**Re: Old Framingham Road Sidewalk Extension and Roadway Realignment NOI
Response to Comments**

TO: Arthur Allen, EcoTec, Inc.
PREPARED BY: Dan Pasquale, Woodard & Curran
REVIEWED BY: Scott Salvucci, Woodard & Curran
DATE: March 4, 2021 (Revised March 30, 2021)
RE: Old Framingham Road Sidewalk Extension and Roadway Realignment

TREE PROTECTION

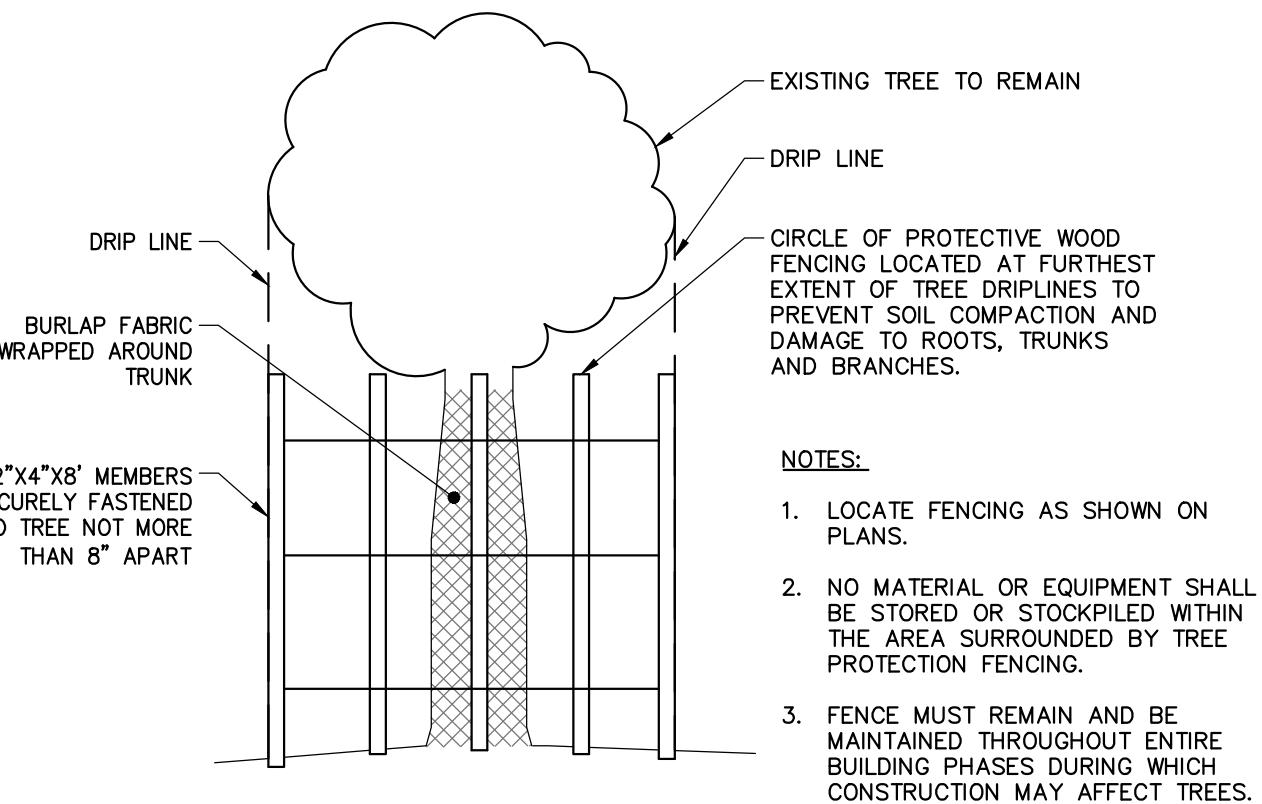
Comment 6: Any tree removal required? Any trees within jurisdiction that are being protected during construction?

Per the discussion at the March 22nd meeting, it is possible that some small trees behind the existing stone wall on Town-owned land south of #78 may need to be removed. One small tree at the south corner of Nobscot Road and Old Framingham Road will need to be removed to accommodate the new intersection alignment—this tree has been called out on the revised sheet C-101. Tree removal will be limited to only those necessary to facilitate construction, and certain trees within or near the limit of work are called out to be protected on sheet C-101.

SEDIMENTATION BARRIER - SILT SOCK

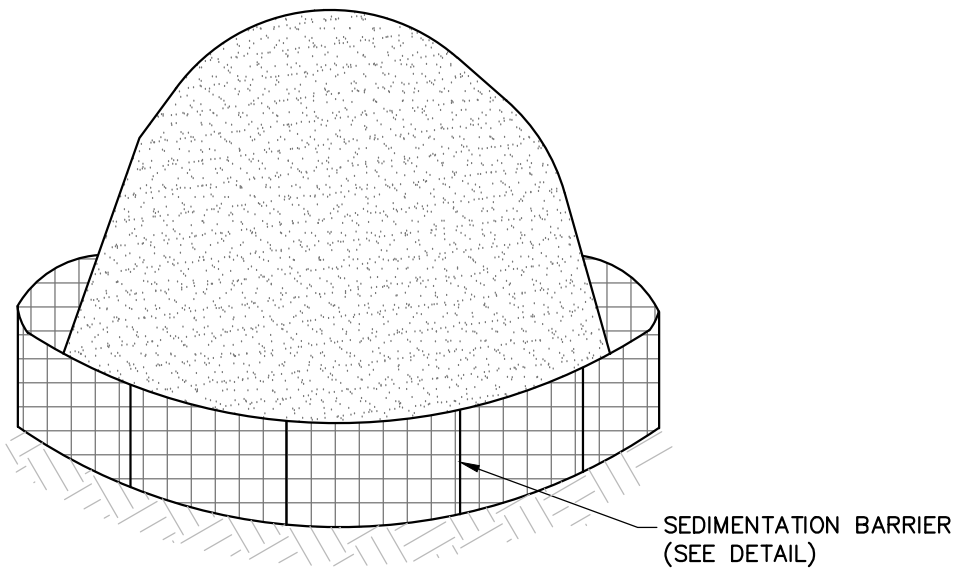
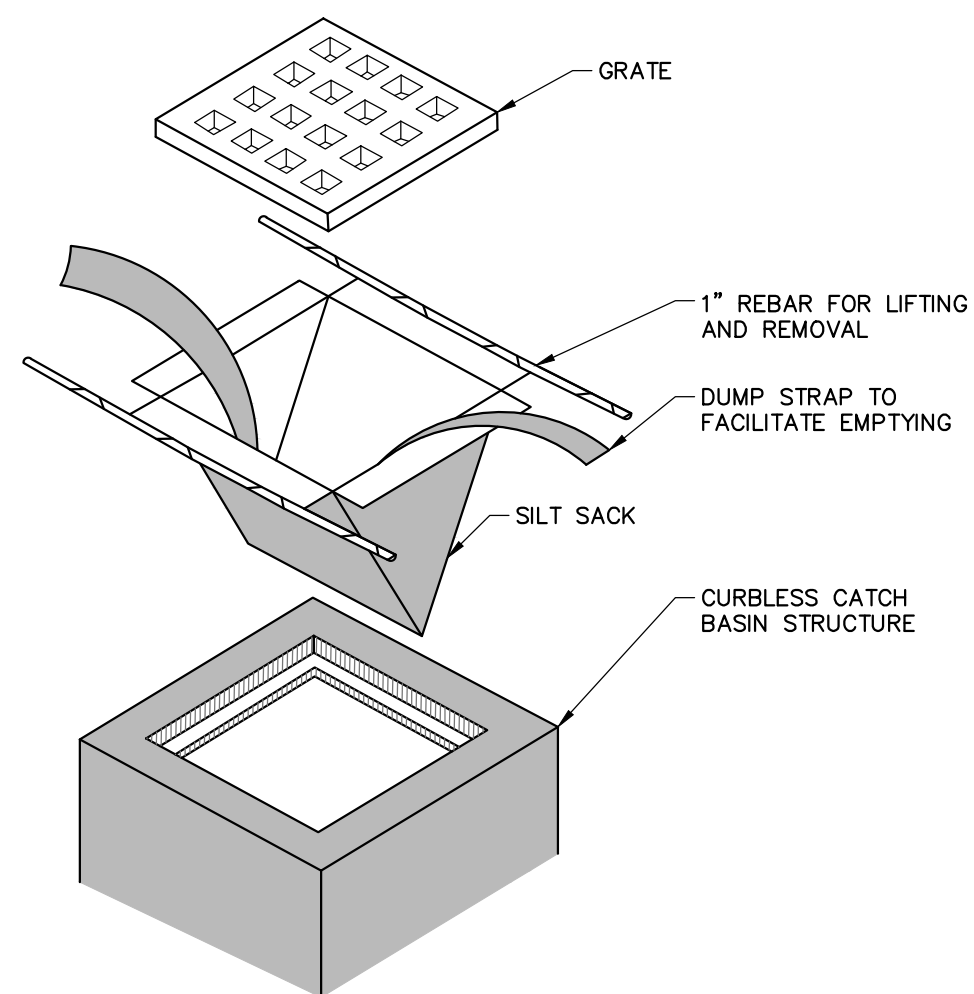
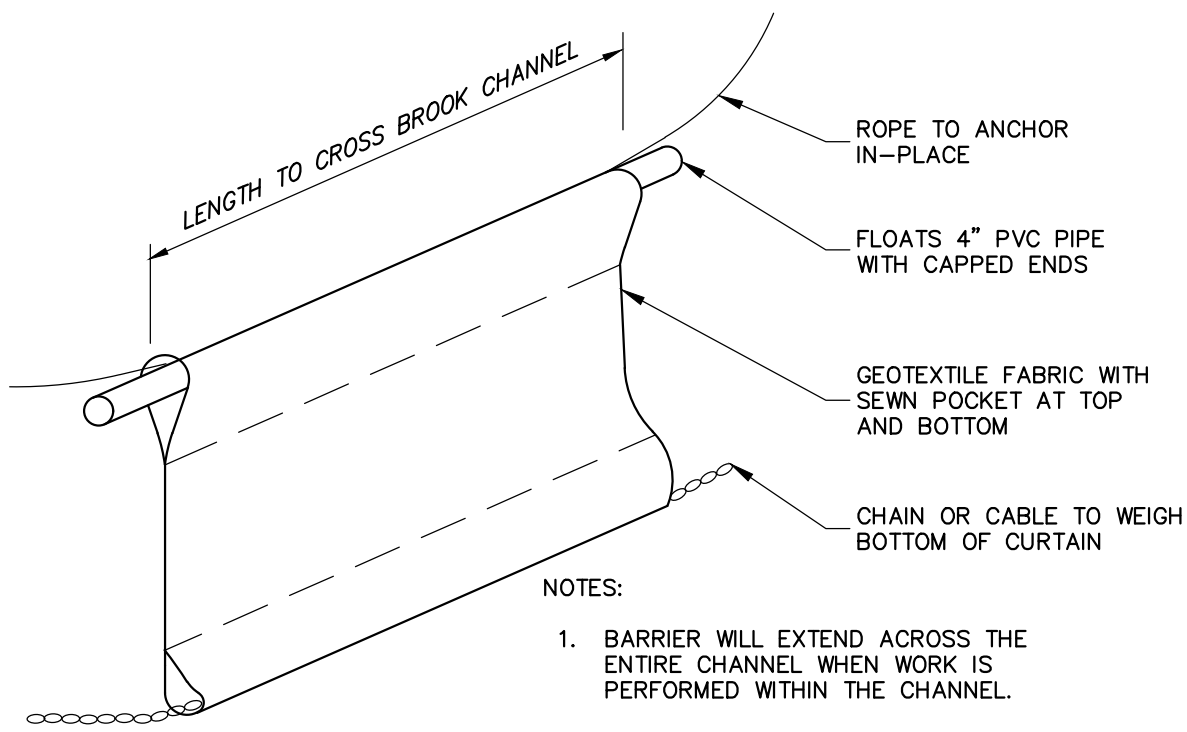
Comment 5: Only silt fence is shown for erosion controls, except for the coffer dam and turbidity curtain. No wattles?

Woodard & Curran recommends using a compostable silt-sock sedimentation barrier. Please refer to the revised sheet C-200 for the Sedimentation Barrier, Dewatering Discharge Sediment Control Device, and Temporary Soil Stock Pile Area details.

Figure 4: Resource Area Impact Figure

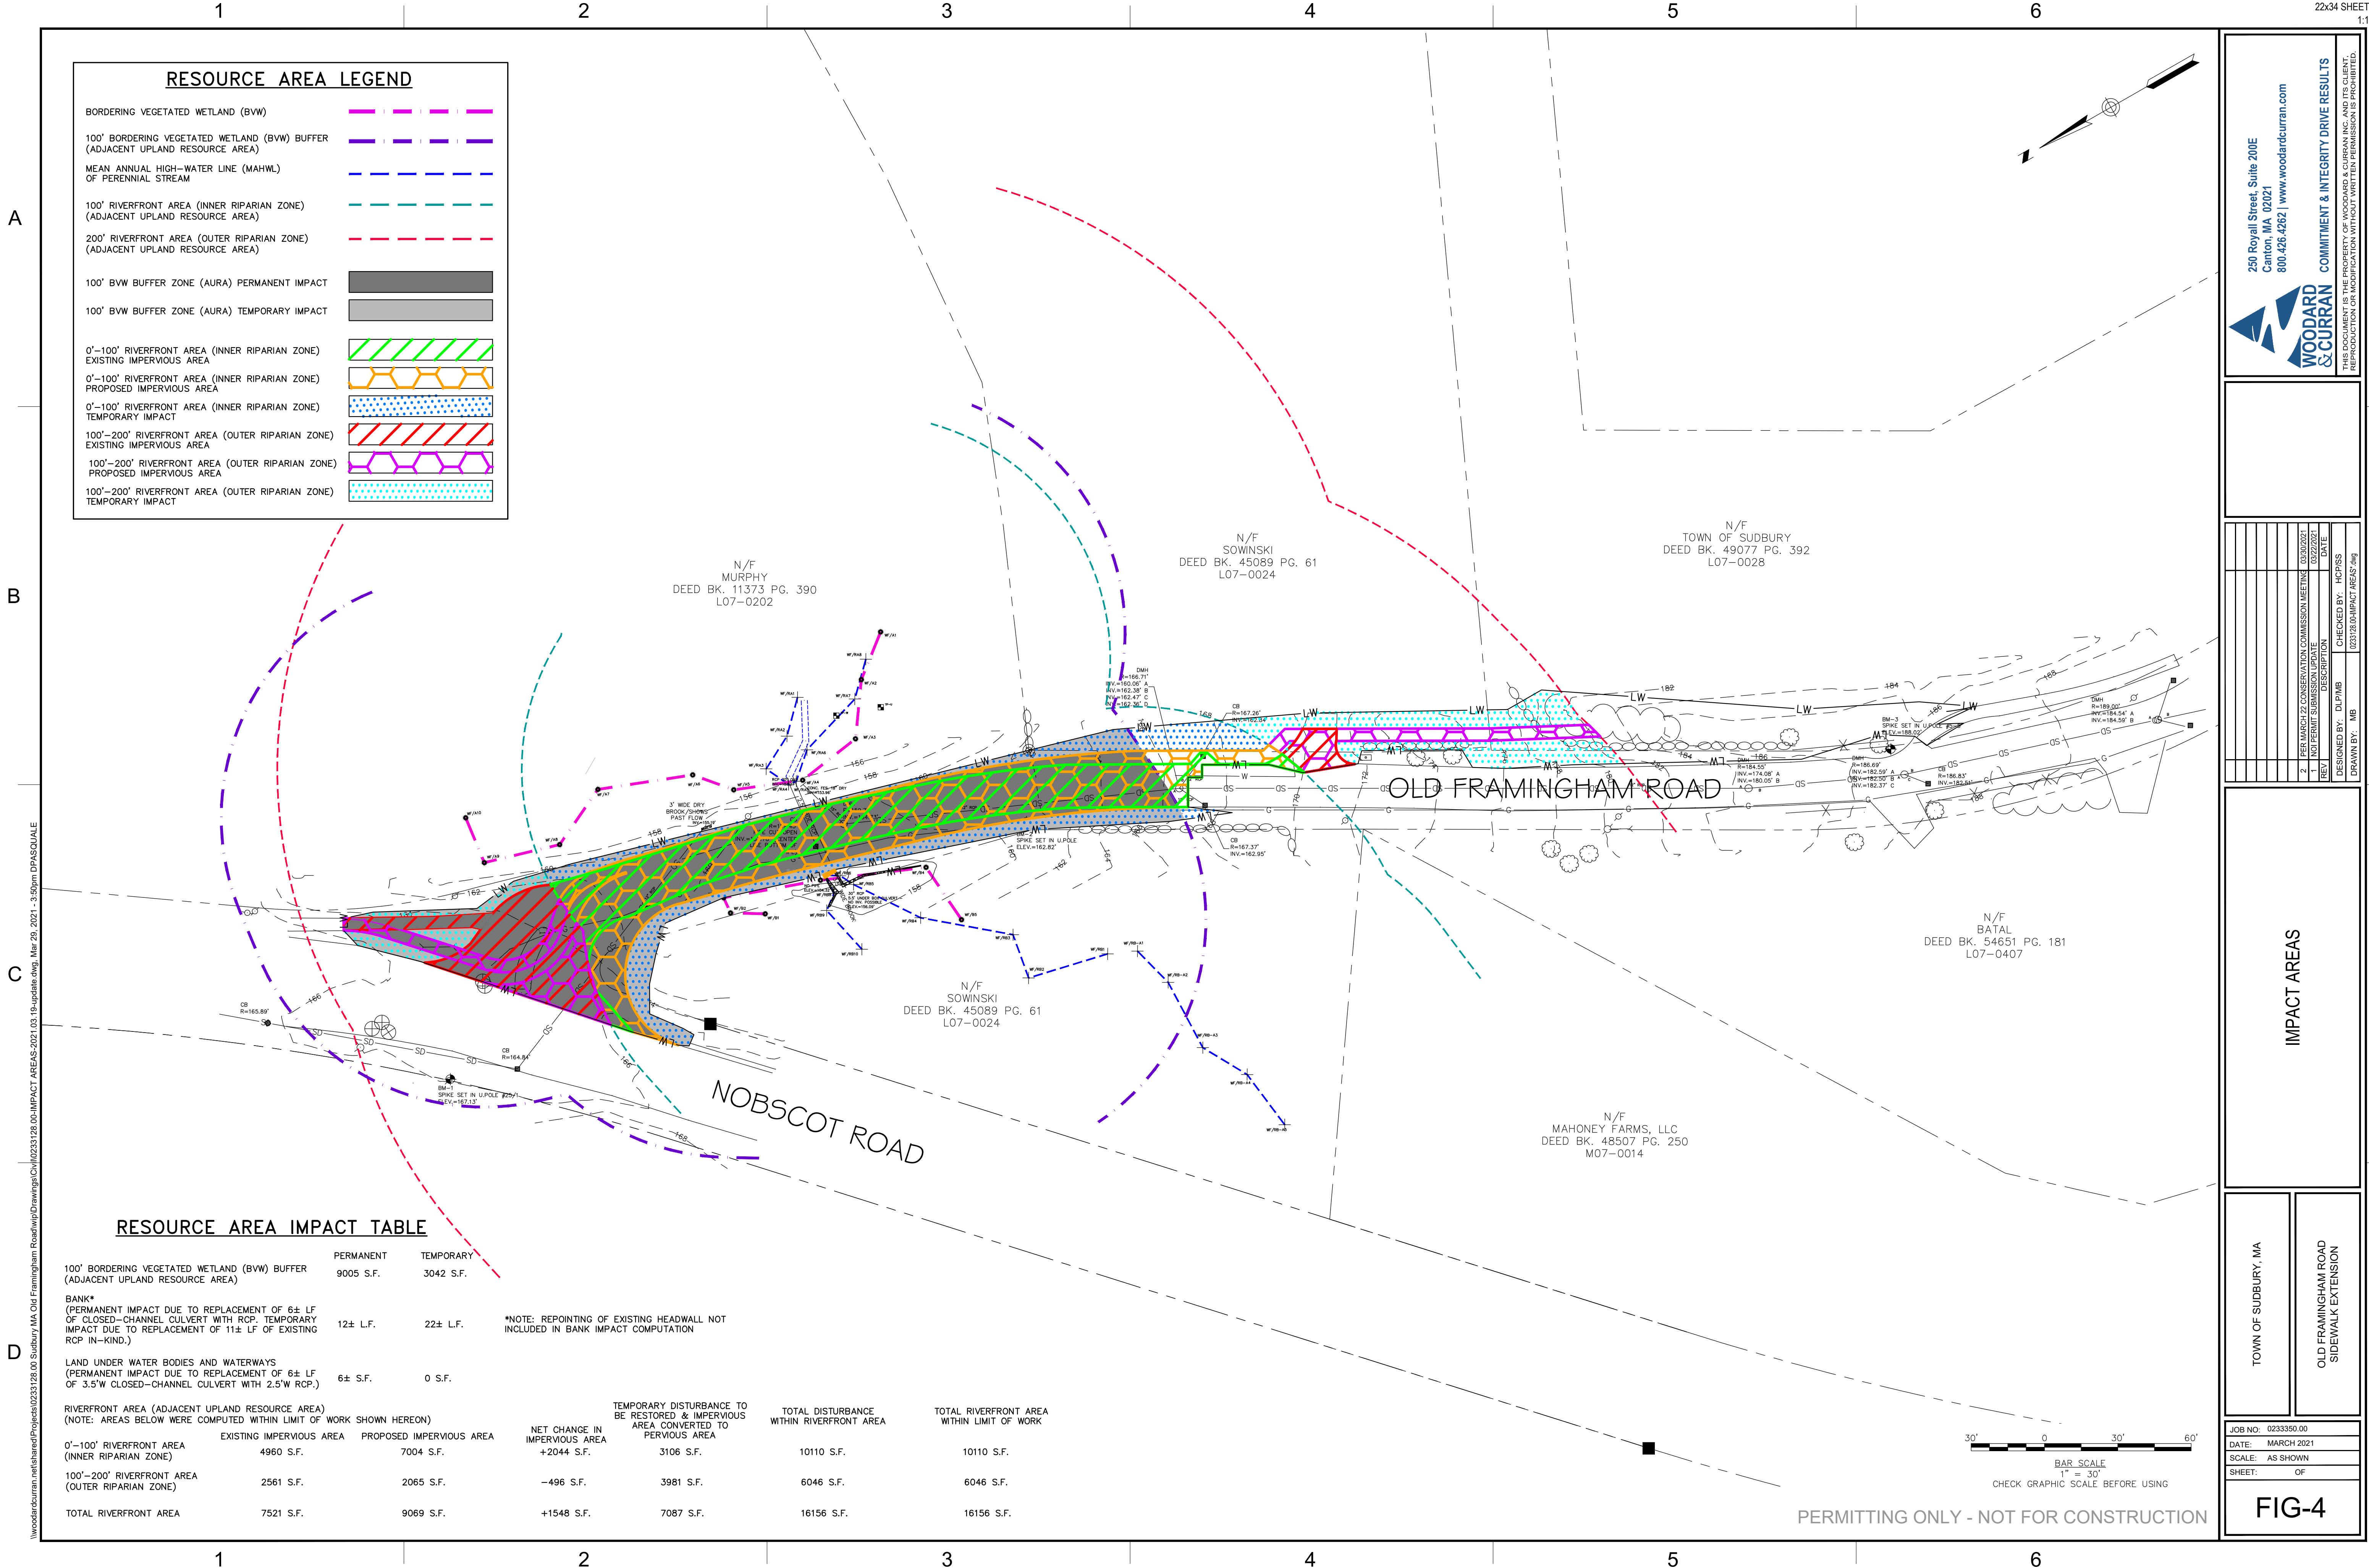
Comment 4: The Riverfront impact calculations in the NOI states that there is 9,069 s.f. of impact, but the Impact Area plan notes 9,069 s.f. of proposed impervious with 5,694, temp disturbance. The NOI should be modified to include with temporary disturbance within the total alteration. The total riverfront calculation in the NOI should include all land within the riverfront area on site. I know this is hard to quantify this type of project but it should not be the total impervious number. Temp alteration numbers should also be included on the NOI form for inner and outer riparian zones.

Please see the revised impact area figure with clarified impact square footage calculations.
